Plan Commission

Revised Agenda

Monday, January 8, 2018

SUBJECT: Recommendation regarding a Site Plan for a new commercial building and parking area called ALDI at 1030 Main Avenue (All of Parcel WD-VA454 and part of Parcels WD-VA-450, WD-VA450-1, WD-VA455-1). Submitted by Garritt R. Bader, Principal, GB Real Estate Inv. LLC.

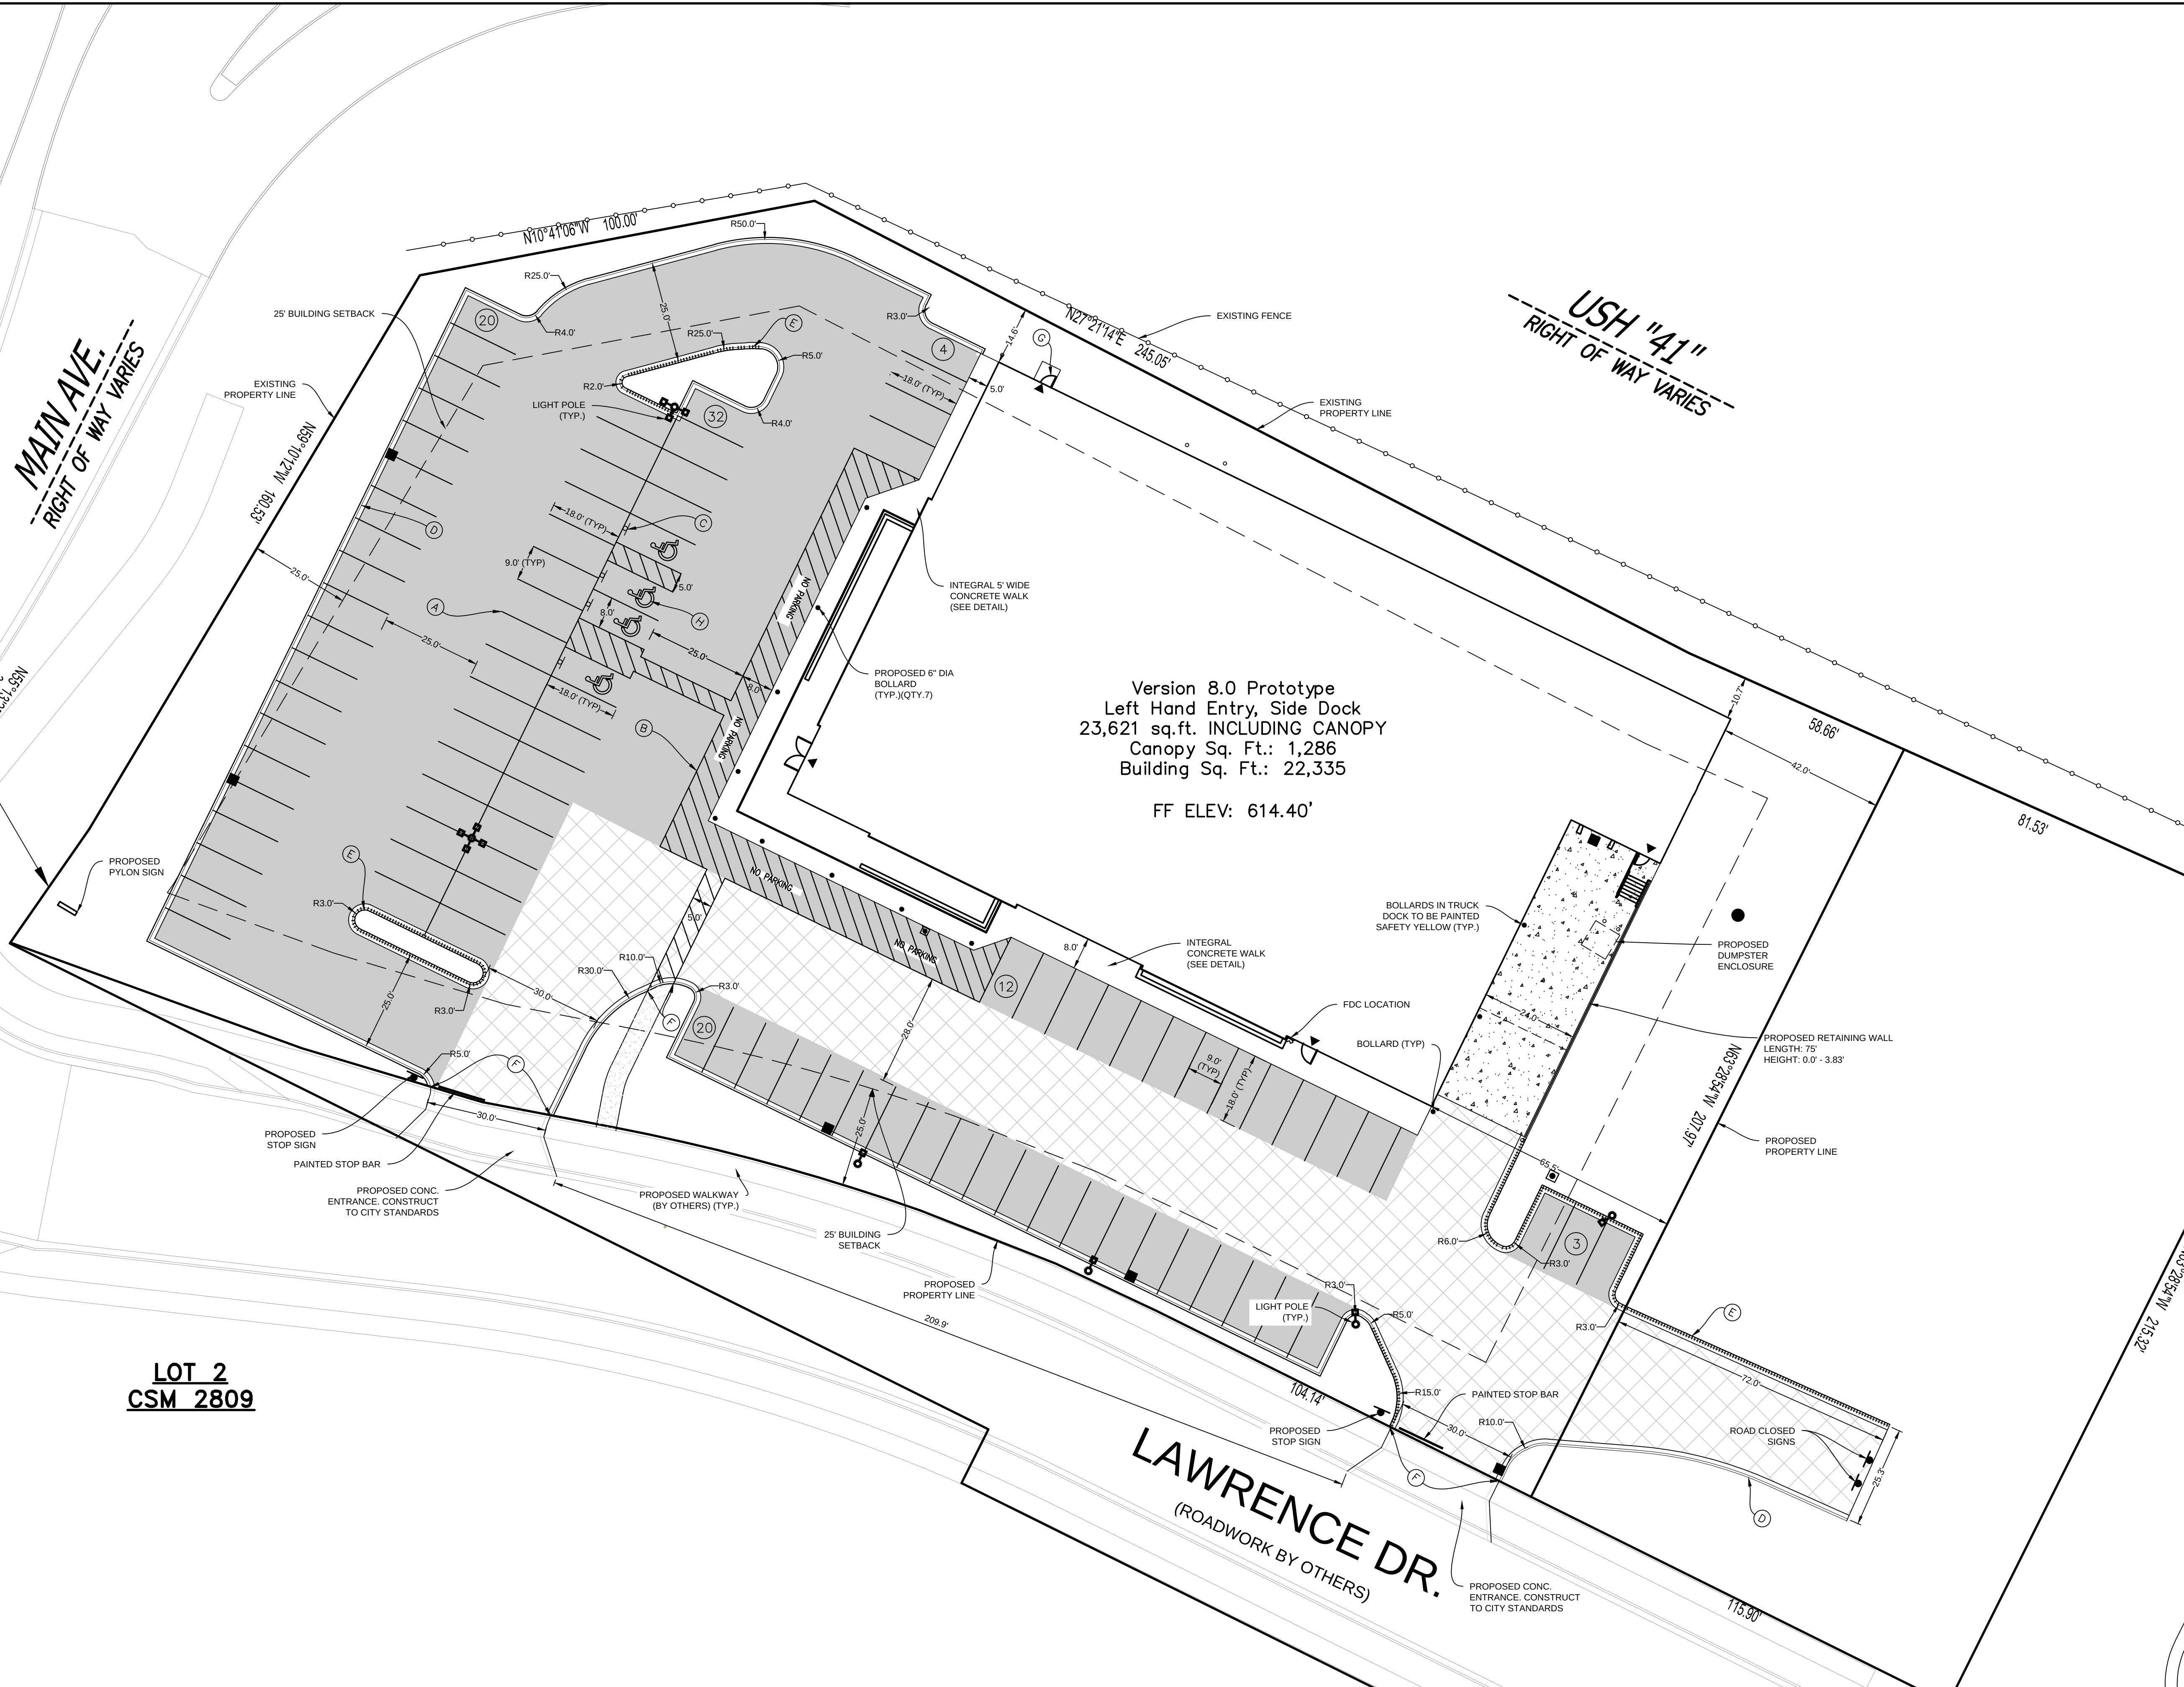
1. If the water meter is greater than a 1-inch, please give the City's Water Department one month advance notice so the meter can be ordered.
2. On Sheets C-3 and C-4, provide ALL boundary lines of the property with the dimensions.

4. Sheet C-3 should show existing services (water, sanitary sewer) coming to the buildings.
5. Pursuant to the WisDOT correspondence dated March 15, 2017: There shall be no driveways on either side of the north leg of the roundabout for 150 feet from the yield line. Please show that the southern driveway is in compliance with this distance.

6. On Sheet C-4 the driveway dimensions at the road need to be shown.
7. On Sheet C-5 the northern driveway's elevations does not match into the roadway elevations. At the center of the driveway, the expected roadway flowline elevation was 610.53. Same for the southern driveway, the expected roadway elevation was 612.81. The City has 90% plans available to verify the roadway sections

SHEET
C-6
C-8

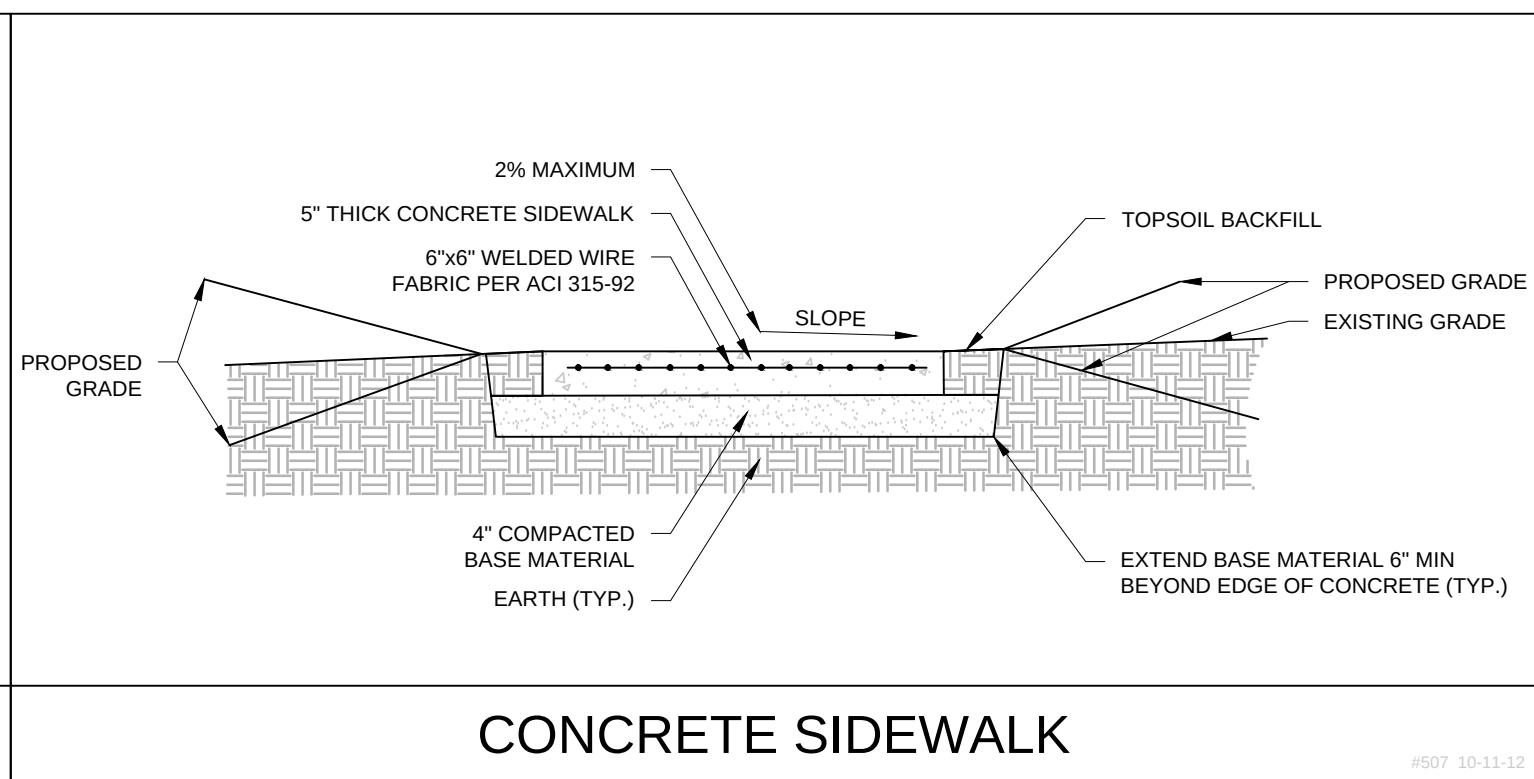
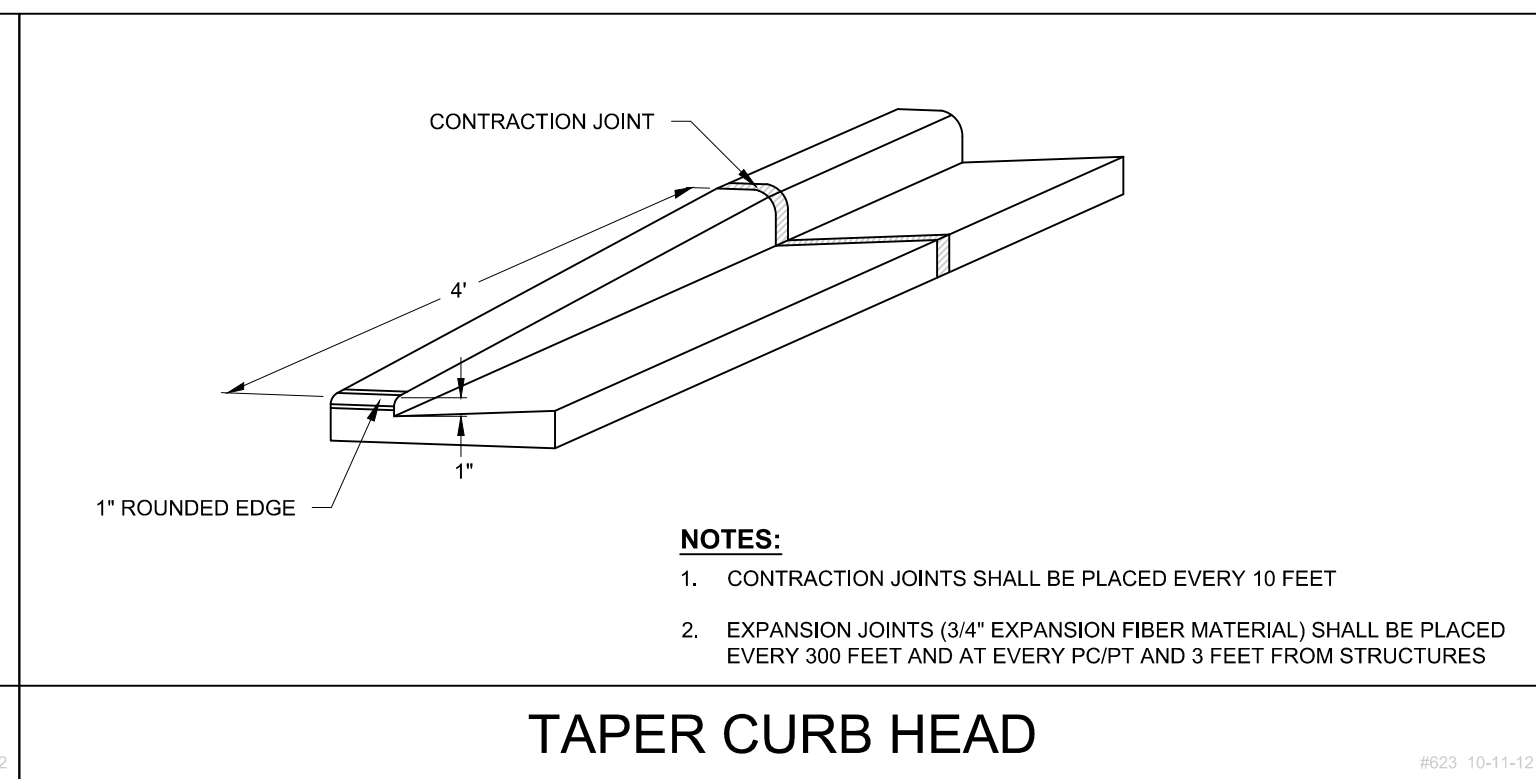
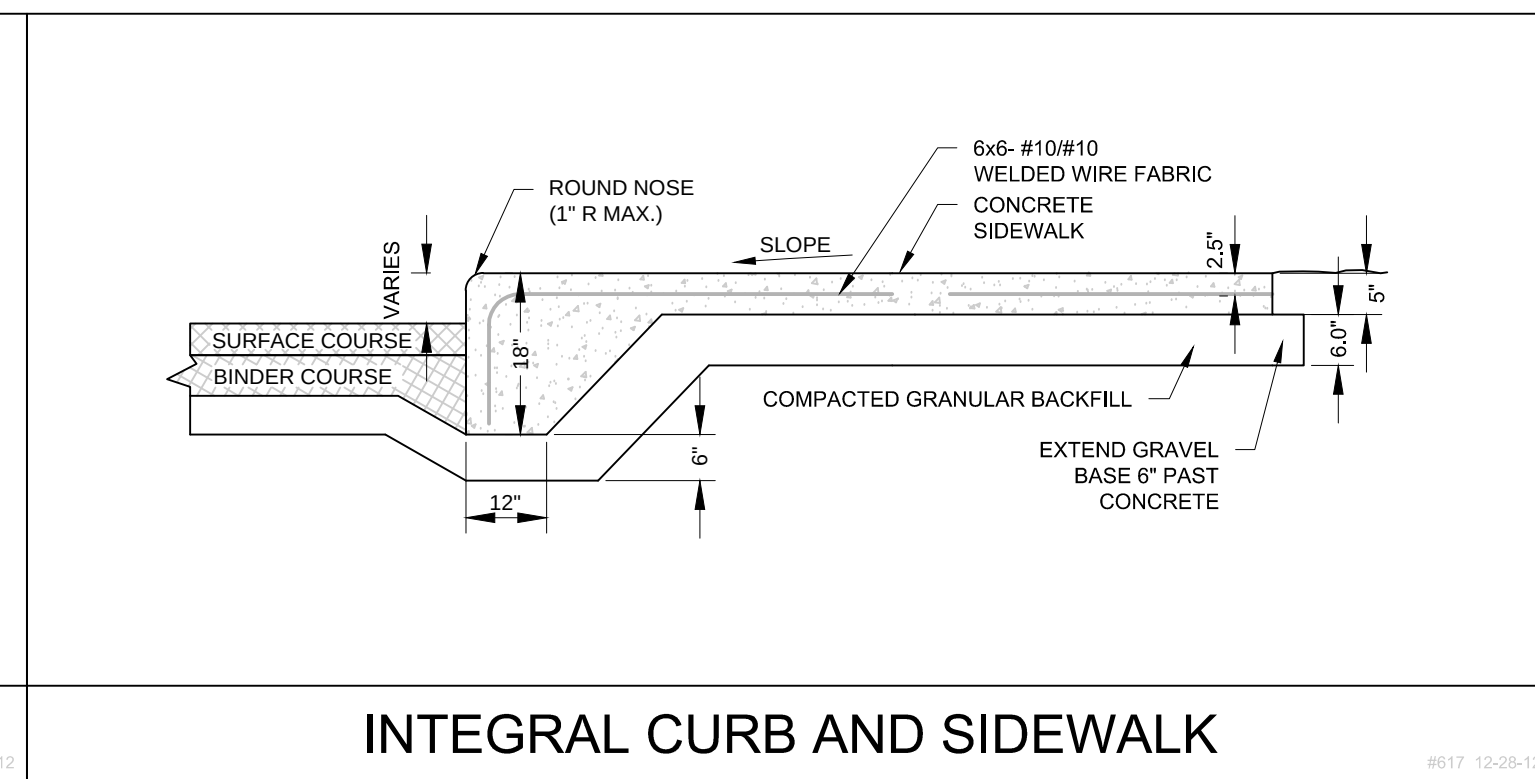
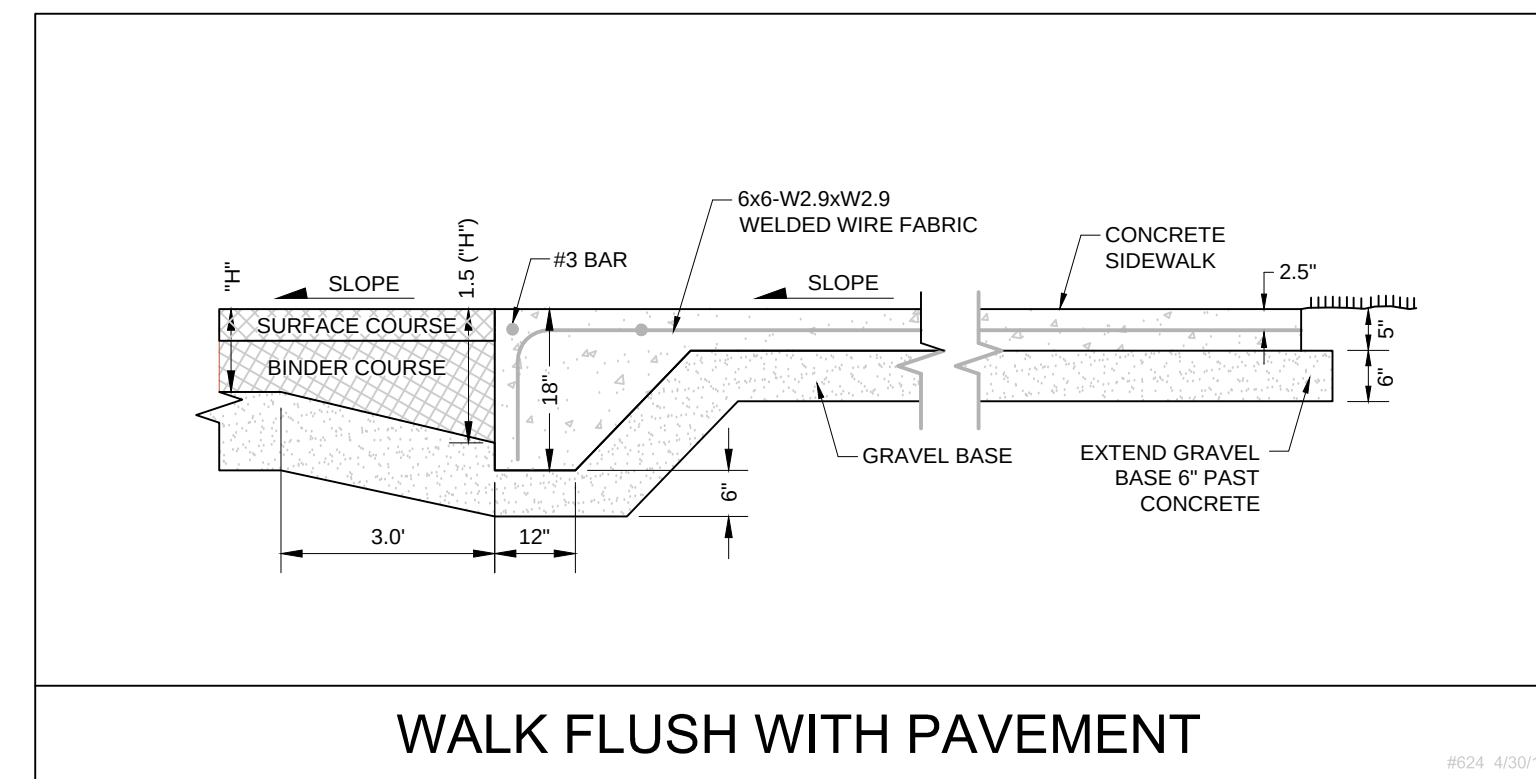
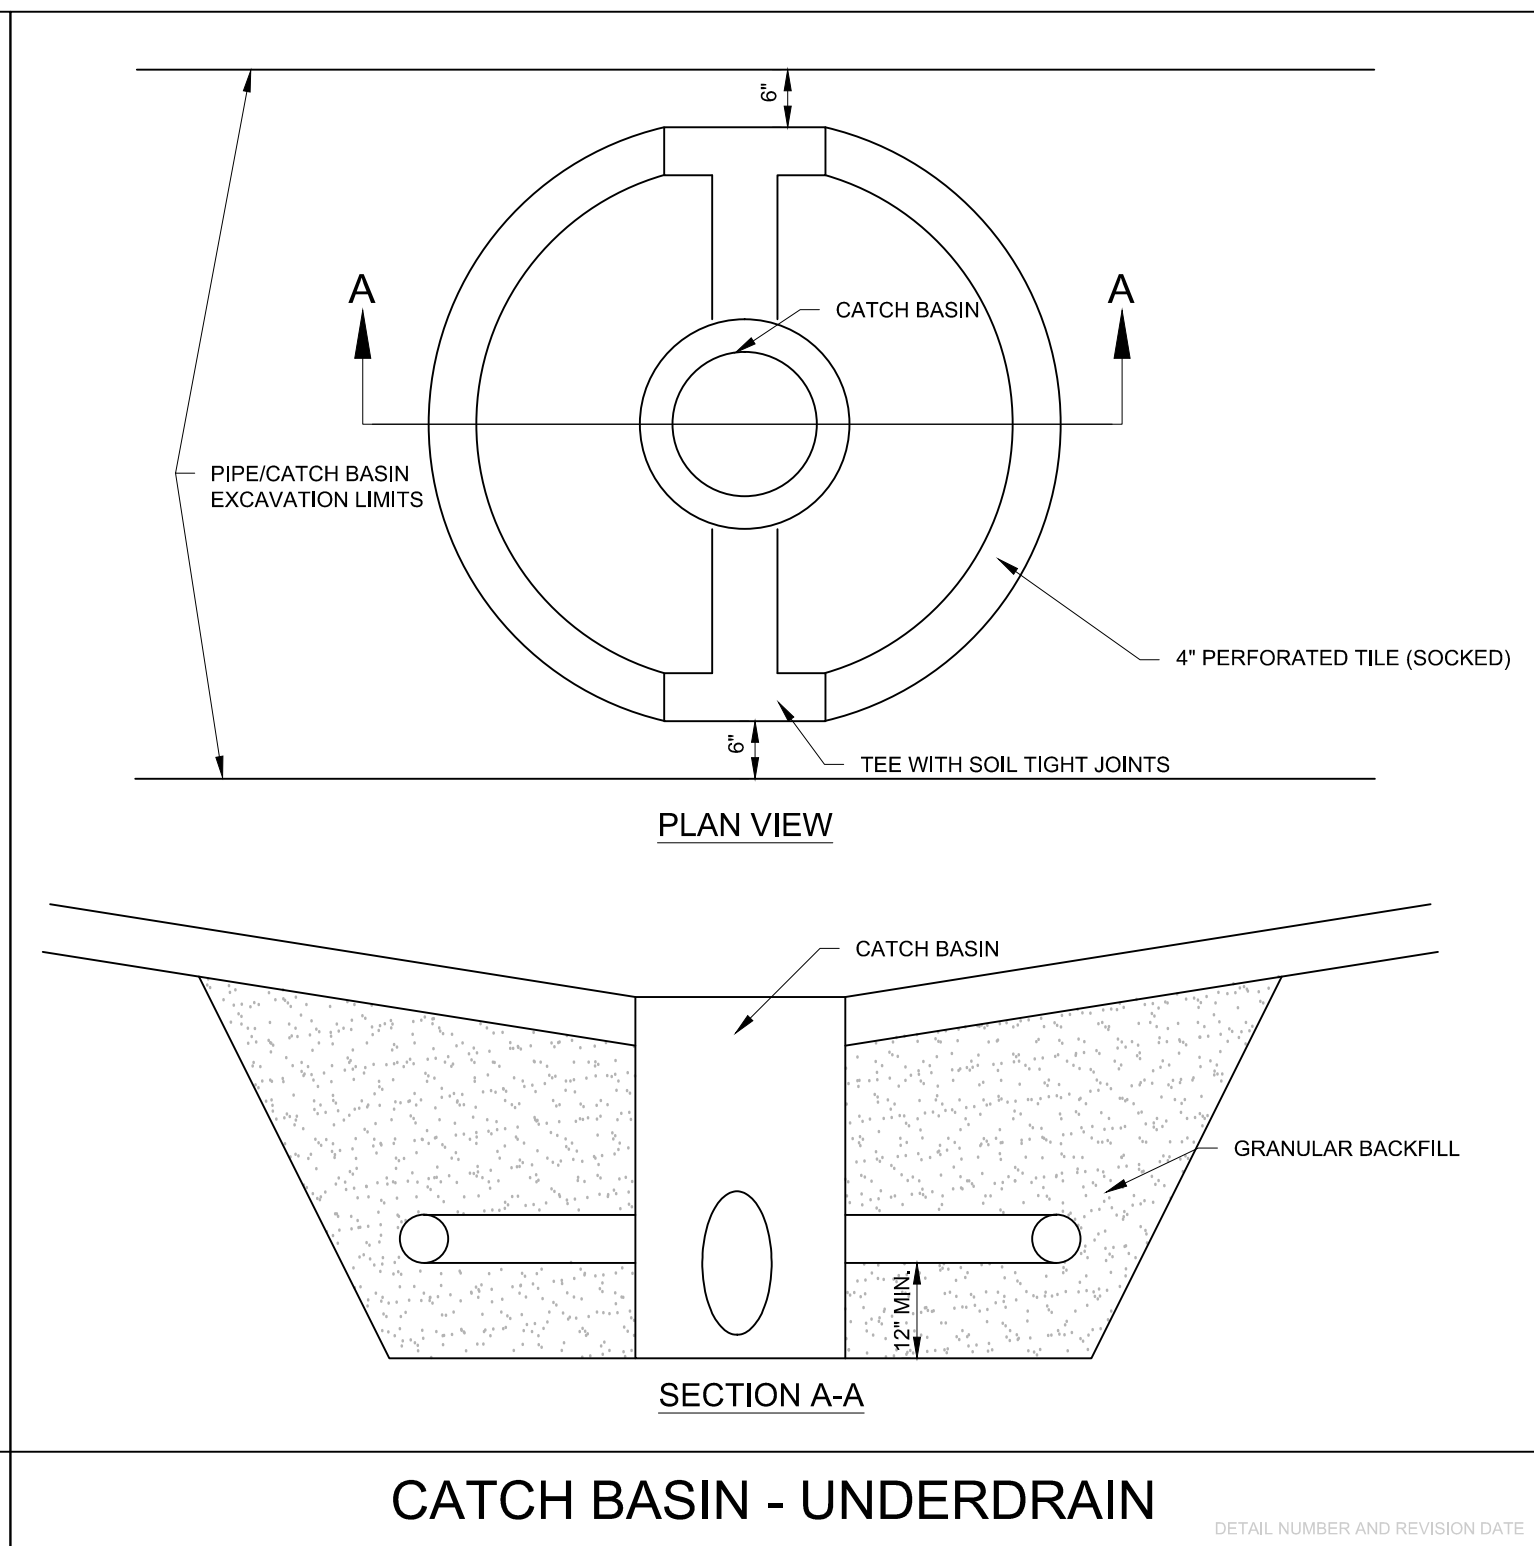
8. On Sheet C-6 the elevation given for the top of the sanitary lateral pipe for crossing three leaves the pipe below the anticipated sanitary stub invert listed on the same sheet. $603.49 - 0.5 = 602.99$, which is below 603.08.
